Addendum 128 – UN Regulation No. 129

Revision 4 - Amendment 3

Supplement 3 to the 03 series of amendments – Date of entry into force: 29 May 2020

Uniform provisions concerning the approval of Enhanced Child Restraint Systems used on board of motor vehicles (ECRS)

Figure 1
Measurement device to check the Sitting Height

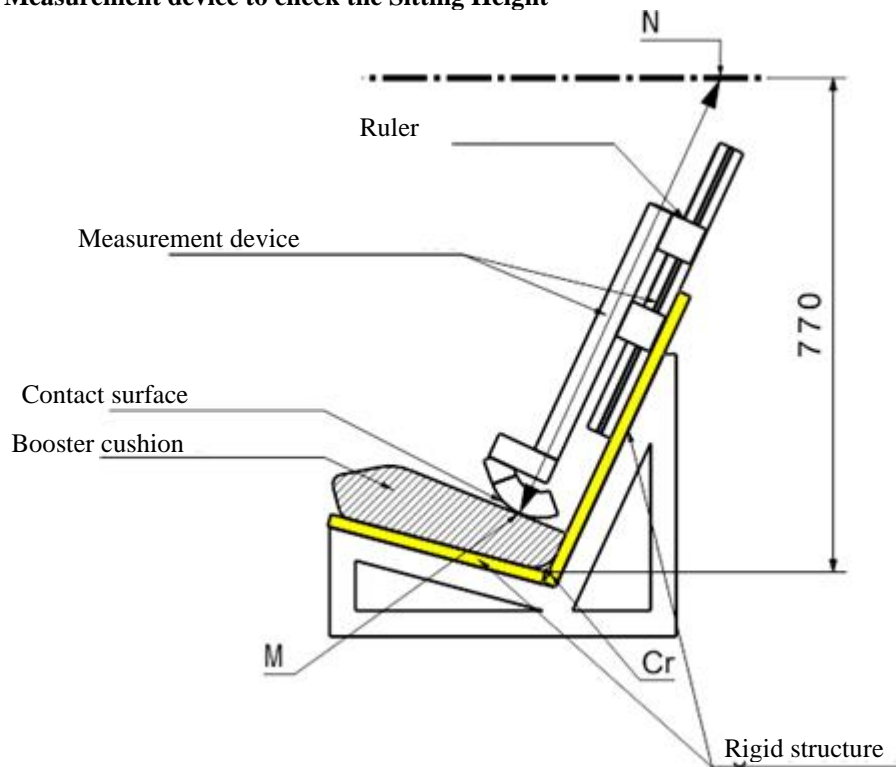
"6.1.3.6. For booster cushions, type approval shall not be granted for a stature below 125 cm. Booster cushions shall not be declared for use below a stature of 125 cm.

Booster cushions shall ensure that the top of the child's head is at or above a horizontal plane at 770 mm vertically from the Cr axis when seated on the test bench described in Annex 6.

The procedure to check if a booster cushion fulfils this requirement is outlined as follows (See Figure 1 below):

- (a) A simulated test bench shall be used for the assessment. The simulated bench shall have the same geometry as the test bench defined in Annex 6 of this Regulation, including the seat cushions. However, the width of the simulated bench may be reduced, if the width is between 500 and 800 mm, as shown in Annex 25. The simulated test bench shall be of rigid construction and shall not deform when using the measuring device defined in Annex 25.

- (b) A rigid structure is attached to the simulated test bench and holds a sliding part. A horizontal plane that is located at a vertical distance of 770 mm from the Cr axis is defined.

- (c) The booster cushion shall be placed on the simulated test bench with its centreline aligned with the centreline of the test bench and the rear surface of the booster cushion contacting the backrest of the test bench.

- (d) If ISOFIX attachments are present these shall be latched with the test bench lower ISOFIX anchorages. An additional force of 135 +/-15N shall be applied in a plane parallel to the surface of the simulated test bench. The force shall be applied along the centreline of the Enhanced Child Restraint System and at a height of no more than 100 mm above the simulated test bench seat surface.

- (e) The measurement device is extended downwards parallel to the simulated test bench backrest, until it is stopped by the booster seat cushion.

Figure 2
Ruler of measurement device

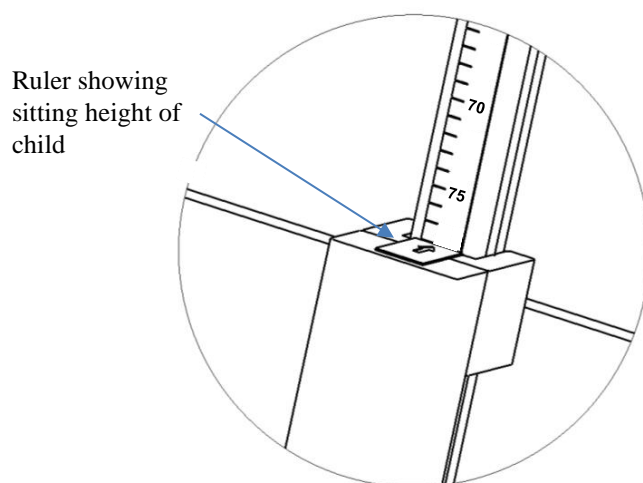
- (f) The measured distance between the two points M and N (Figure 1) represents the sitting height of a child who will use the booster cushion. The corresponding value is displayed by a ruler that is provided with the device as shown in Figure 2.
- (g) Using the data in Table 3, the sitting height is utilized to determine the corresponding minimum stature of the child that can be accommodated by the booster cushion. Example: A sitting height of 66.2 cm shall correspond to a child minimum stature of 125 cm; a sitting height of 75.9 cm shall correspond to 150 cm.

In case the value obtained for the sitting height is between two integer values always round up to the next integer value (e.g. Measured sitting height = 70.1 cm ► resulting stature = 135.65 cm ► Smallest stature allowed = 136 cm).

- (h) The stature determined in this procedure shall be compared to the lower limit of the approval stature range. The requirement is fulfilled if the lower approval stature is greater or equal than the obtained minimum stature.

1. Arrangements of the approval mark

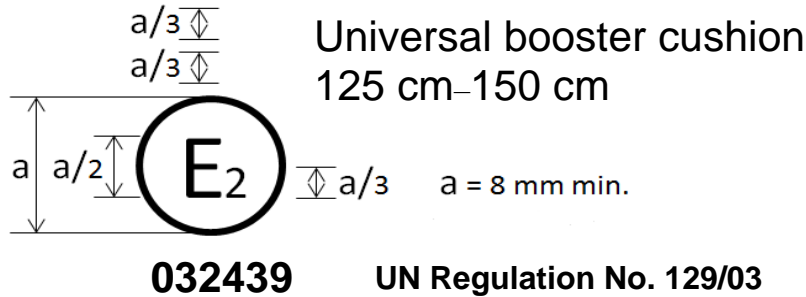
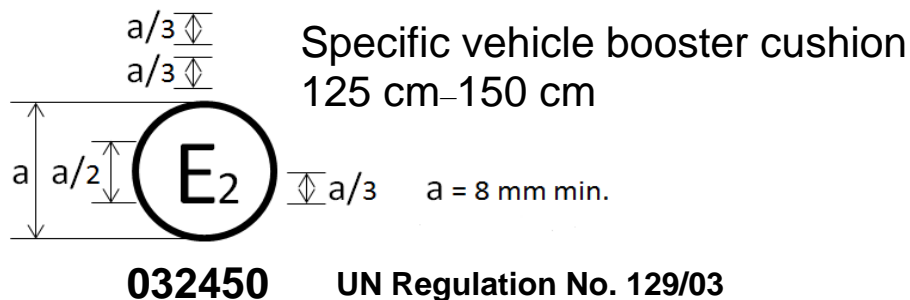
The Enhanced Child Restraint System bearing the above approval mark can be fitted in any i-Size seating position and Universal seating position, and used for the 125 cm–150 cm size range; it is approved in France (E 2) under the number 032439. The approval number indicates that the approval was granted in accordance with the requirements of the Regulation concerning the approval of Enhanced Child Restraint Systems used on-board of motor vehicles as amended by the 03 series of amendments. In addition, the name of the Regulation is to be identified on the approval mark followed by the series of amendment according to which the approval has been granted.

The Enhanced Child Restraint System bearing the above approval mark is a device not capable of being fitted in every vehicle but is capable of being used for the 125 cm–150 cm size range; it is approved in France (E 2) under the number 032450. The approval number indicates that the approval was granted in accordance with the requirements of the Regulation concerning the approval of specific vehicle booster cushion Enhanced Child Restraint Systems used on-board of motor vehicles as amended by the 03 series of amendments. In addition, the name of the Regulation needs to be identified on the approval mark followed by the series of amendment according to which the approval has been granted.

Device to measure the booster cushion height

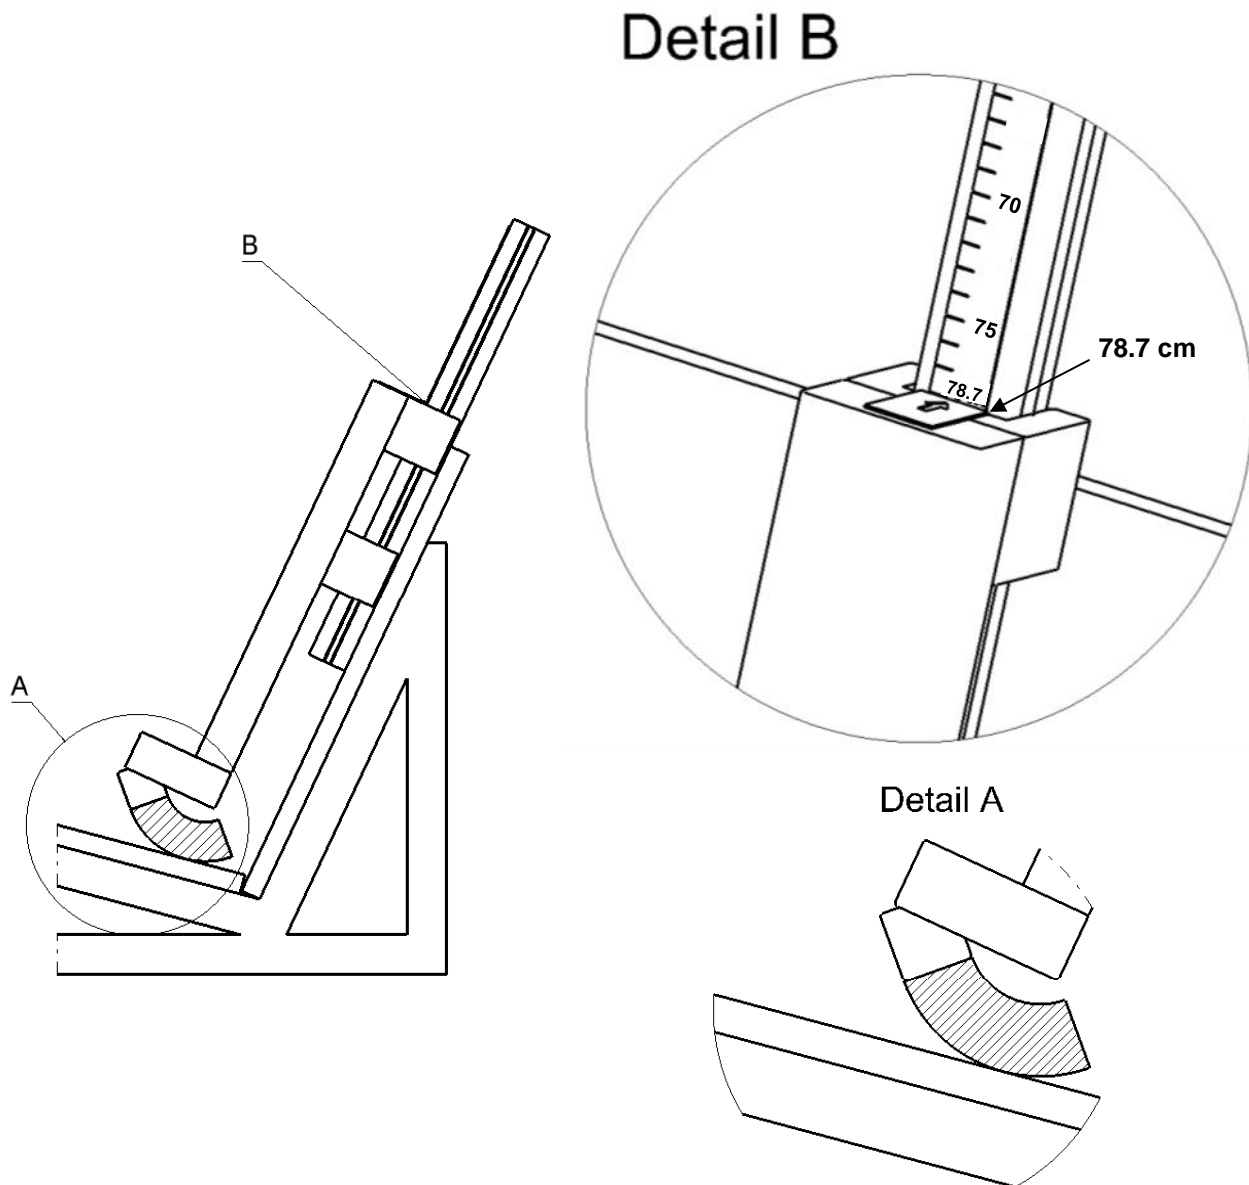
The mass of the device shall be 15kg +/-1kg

Calibration of the measurement scale

To calibrate the ruler of the measurement device, its structure shall contact the supporting surface (Detail A). In this configuration, the scale shall show the calibration value of 78.7 cm (Detail B).

The calibration of the ruler is based on the sitting height of the Hybrid III 5th percentile dummy seated on the test bench defined in Annex 6 of this Regulation. When this dummy is seated on the test bench, the top of the head is 77.0 cm from the Cr axis. The nominal sitting height of the dummy is 78.7 cm. Therefore, 78.7 cm is used as the calibration value.

Manikin block (based on truncated P10)

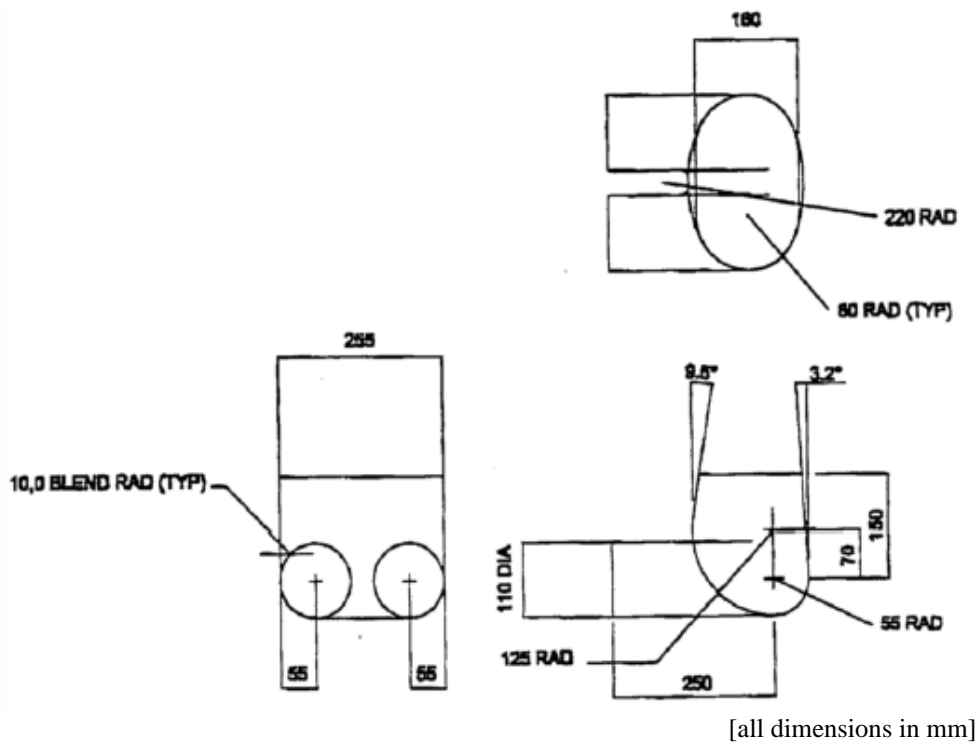
Place a cotton cloth on the seating surface of the test bench. Position the booster cushion on the test bench, position the lower torso body block as described in Annex 26, Figure 1, on the seating surface, fit and apply the 3-point adult safety-belt and tension as prescribed in paragraph 7.1.3.5.2.2. With a strip of 25 mm-wide webbing or similar, tied around the booster, apply a load of 250 ± 5 N in the direction of arrow A (see Annex 26, Figure 2), in line with the seating surface of the test bench.

Material: Expanded polystyrene (EPS) (40 to 45 g/l) or alternative non-deformable material

Booster pull test using manikin block

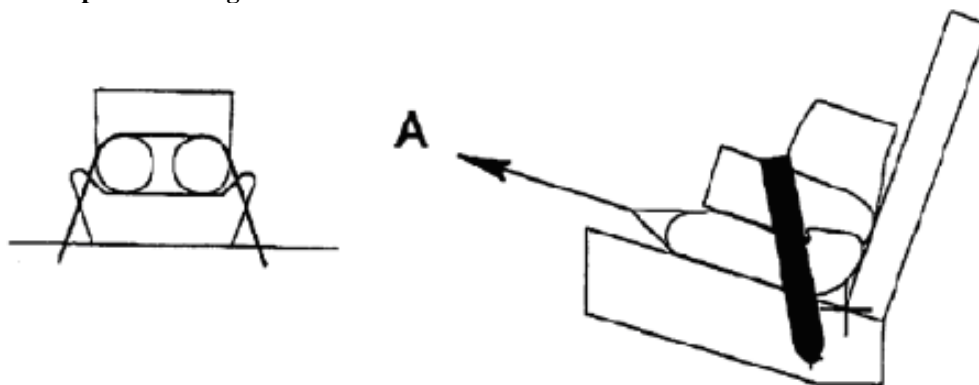
The booster cushion shall not be pulled completely out of the 3-point adult safety-belt and shall remain under the body block during the test."
